From: Scala, Mary Joy
Sent: Monday, December 28, 2015 10:29 AM
To: William H. Atwood (atwood@scscharlottesville.com)
Cc: btreakle@jetreakle.com
Subject: BAR Action – December 15, 2015 –501 West Main Street

RE: Certificate of Appropriateness Application
BAR 15-09-05
425,501,503 West Main Street
Tax Parcel 320175000, 320176000, 320177000
William H. Atwood, Applicant/The Sutton Group, Owner
Massing and elevations approval for a new mixed use development

**CITY OF CHARLOTTESVILLE
BOARD OF ARCHITECTURAL REVIEW
STAFF REPORT
December 15, 2015**

BAR 15-09-05

A1.1

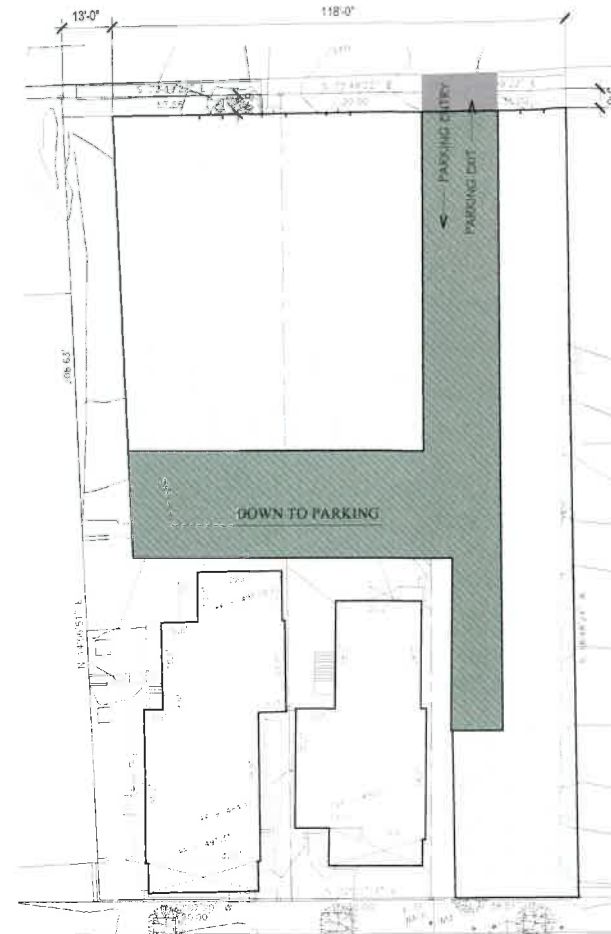
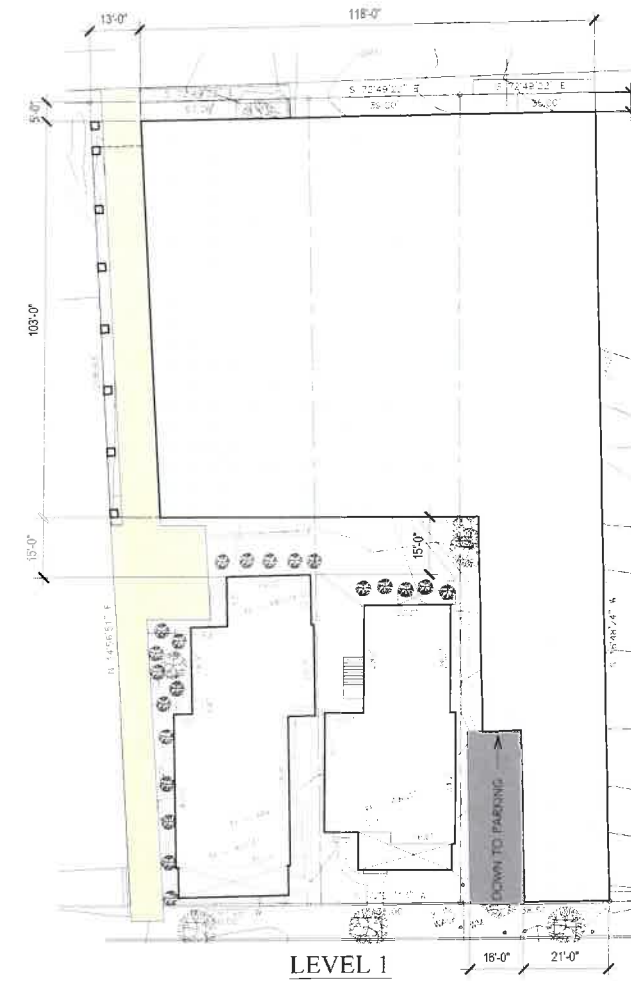
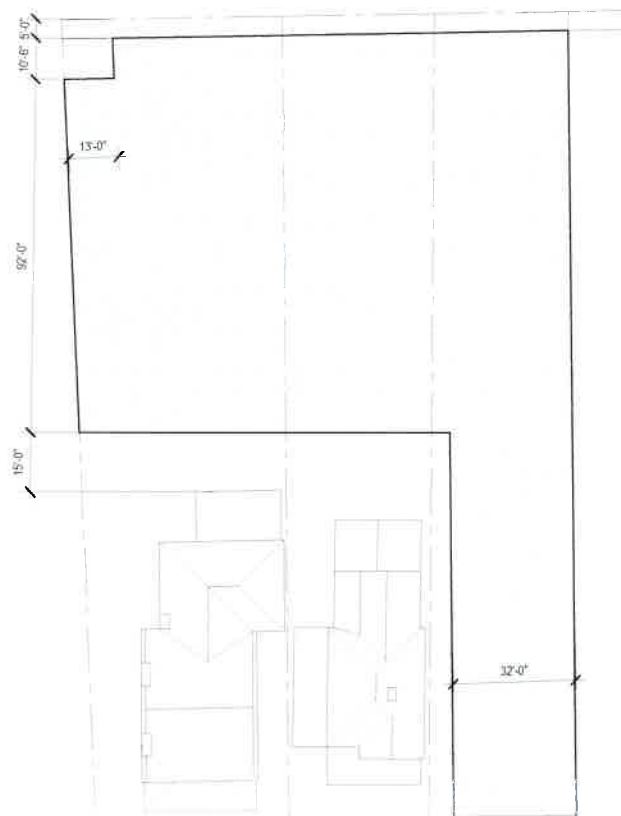
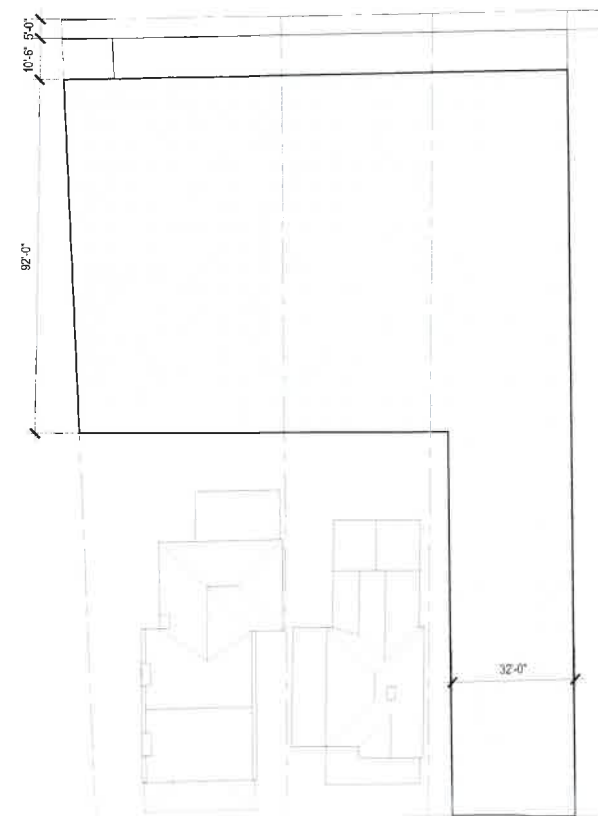
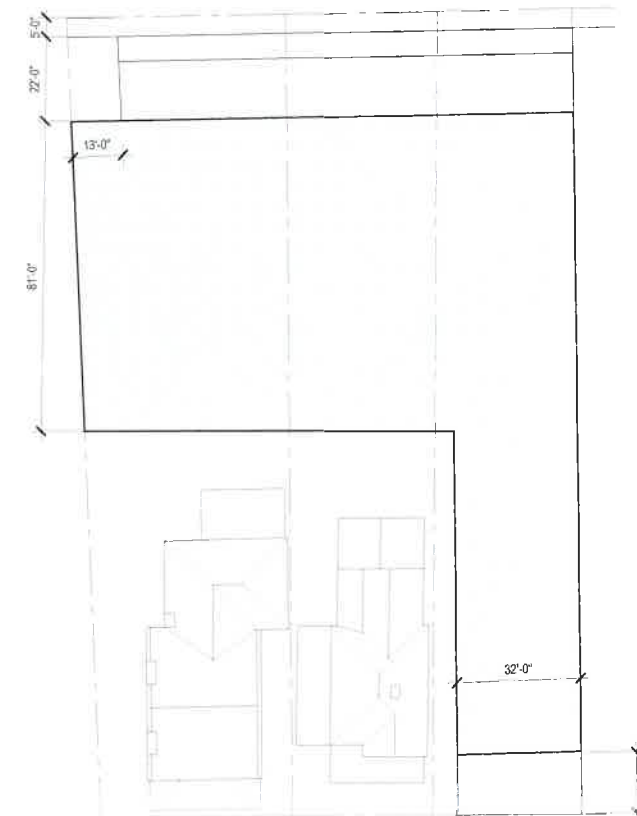
The entrance to the parking garage on West Main Street is identified as a “Drive Down” ramp and is dimensioned as 16’ in width on sheet A1.1. The scale and use of this type of garage entry seems more appropriate to dense and spatially constrained urban conditions, and not the streetscape of Charlottesville in this critical section of West Main Street.

Level 1 of the proposal is annotated as a "Parking Plaza", which creates a programmatic adjacency that diminishes the historic character of the properties. A better use of this floor level would be commercial or other publicly accessible uses that can leverage the aesthetic appeal of the historic structures. While programming may not be in the purview of the BAR, it is worth noting that the design is not sympathetic with the unique historic character of the site.

1. Eliminate the "Drive Down" garage entrance on West Main Street.
2. Reduce the parking to the minimum required by zoning and building code and eliminate parking on Level 1 (ground level of Main Street) of the project.
3. Increase the 15' set-back between the project and the historic properties to a minimum of 30' to allow for semi-public uses like outdoor commercial modeled on the design of the 505 West Main complex.
4. Provide for a reasonable set-back between the historic property at 501 West Main and the proposal scaled for pedestrian circulation and access to the rear setback.
5. Recommend that the applicant voluntarily reduce the building height to the proposed height being considered by the Planning Commission.
